Re: Florida Power & Light Company
Proposed Turkey Point Units 6 and 7
Docket Nos. 52-040 and 52-041
Supplemental Submittal to NRC Request for Additional Information Letter No. 64
(eRAI 6544) Related to SRP Section 03.05.03 - Barrier Design Procedures

Supplement to eRAI-6544, TPG-GW-GLR-001

NRC RAI Number: 03.05.03-34

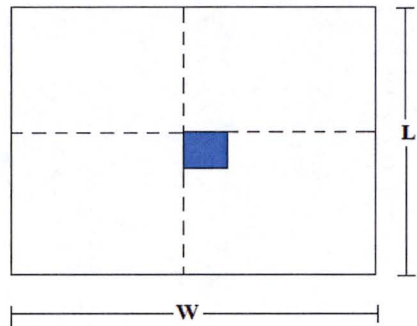
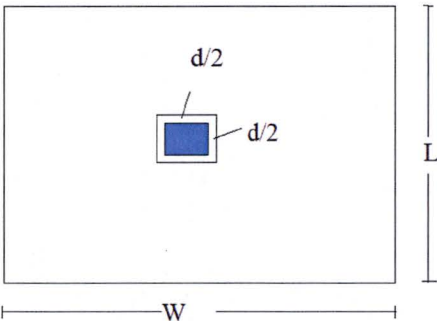
Two questions resulted after a phone call with the NRC on September 03, 2015, requesting further clarification on hurricane missiles.

Wall 5 is used as an example to demonstrate how the shear allowable is calculated for one-way and two-way shear. Shear allowables are in compliance with ACI349-01.
